PART 21 REPORT - POTENTIAL FAILURE OF BONNET VALVE

Subject: USNRC 10CFR Part 21 Notification

Ref: Flowserve Size $\frac{3}{4}$ Figure 848Y Disk/Disk Nut Separation
LaSalle Station
Exelon PowerLabs, LLC Project Number: LAS-62808
Flowserve Complaint Report 4914
Flowserve Evaluation Report No. 10 CFR 21-50

Figure 1 Stem/Disk Assemblies for Old Design and New Design Figure 848 / A848 Valves.

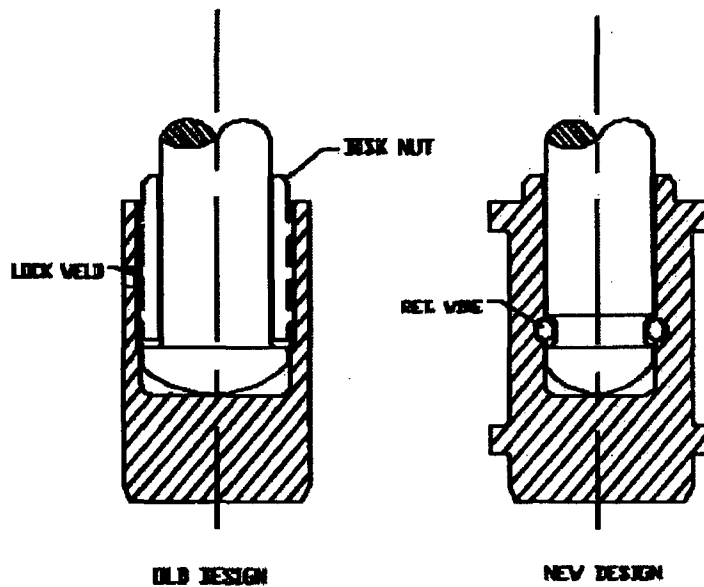
Figure 1 provides an illustration of the stem/disk assembly in the Size $\frac{3}{4}$ Figure 848 valve. The **"Old Design"** is typical of the valve that is the subject of this discussion. The valve stem has a collar on the very end. After the stem is inserted into the disk, the disk nut is threaded into the disk to retain the stem. A lock weld is then created to prevent the disk nut from unthreading out of the disk.

In about 1990, the design was changed to that shown as the **"New Design"** in Figure 1. The disk nut was eliminated, and the disk retained on the end of the valve stem using a piece of wire inserted into a groove located half in the valve stem and half in the disk.

For the case of the **"Old Design"** valve at LaSalle, once the disk nut has unthreaded out of the disk, the stem and the disk are no longer connected. The valve will then operate as a stop-check valve. The valve will open in response to normal forward flow, and close in response to normal reverse flow.

After unthreading from the disk, the disk nut will sit on top of the disk. The valve will be able to open only partially, because the disk nut will interfere with the ability of the valve to open fully. The amount that the valve can open will depend on the size of the valve. For the Size $\frac{3}{4}$ valve at LaSalle, the disk would be able to open less than $\frac{1}{8}$ of an inch. The amount that other valve sizes would be able to open is different, but all would be reduced.

The valves affected are Size 2 and smaller Edward Figure 848 valves manufactured by Rockwell International at the Sulphur Springs, Texas, and the Raleigh, North Carolina, manufacturing facilities prior to 1991. These valves may be tagged "Rockwell", "Rockwell Edward" or "Edward". The valves affected have the "**Old Design**" stem/disk assembly shown in Figure 1.

Valves with Figure Number **A848** incorporate the "**New Design**" stem/disk connection and are not affected.
